2018 Mercedes Benz E63S AMG 4MATIC Sed (213.089) V8-4.0L Turbo (177.980)

## CREAKING NOISES FROM SEAT CUSHION LENGTH ADJUSTMENT (SKTE) IN VEHICLES WITH MEMORY PACKAGE (CODE 275)

<b>Topic number</b>	LI91.10-P-067673
<b>Version</b>	1
<b>Function group</b>	91.10 Front seats
<b>Date</b>	02-02-2018
<b>Validity</b>	BR 213 with SA code 275 (Memory Package) up to manufacturing date 16.03.2017
<b>Reason for change</b>

Pic.1

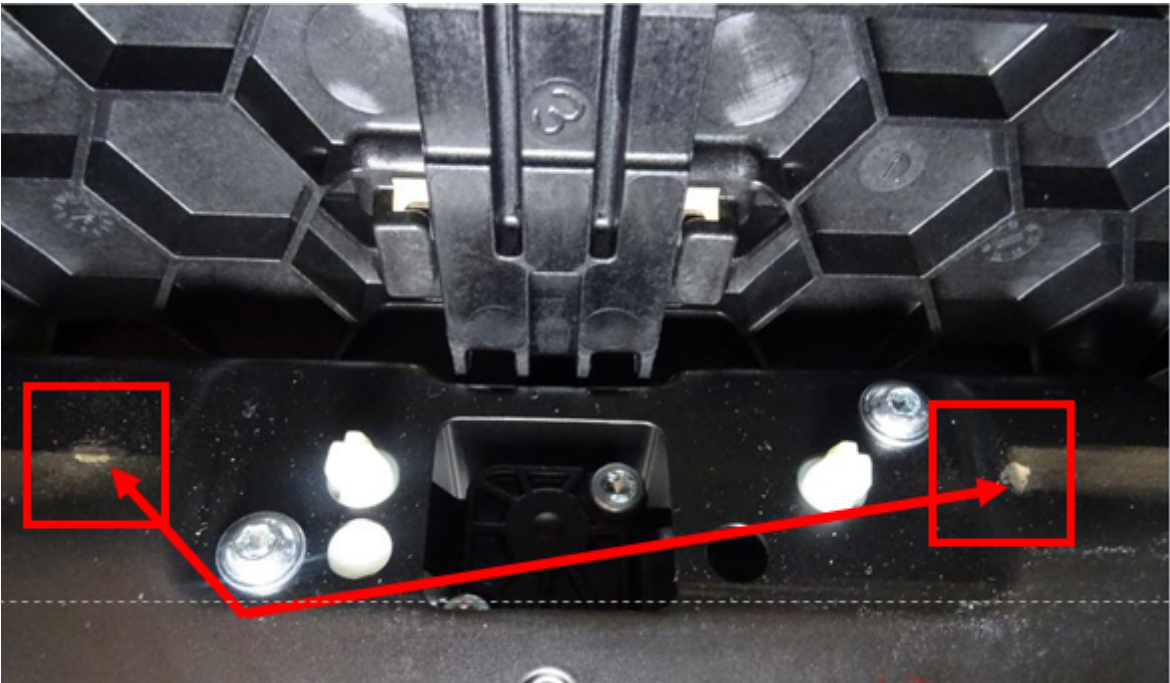
Contact between plastic lever of seat cushion and cushion shell (signs of abrasion visible on cushion shell).

Signs of abrasion on cushion shell. No felt attached.

- Remove seat cushion cover and seat cushion padding
- Stick felt strips (approx. 10x8 cm) onto cushion shell of seat (see pictures, illustrated without the SKTE lever). It is not necessary to remove the seat for this.

Felt strips attached to cushion shell.
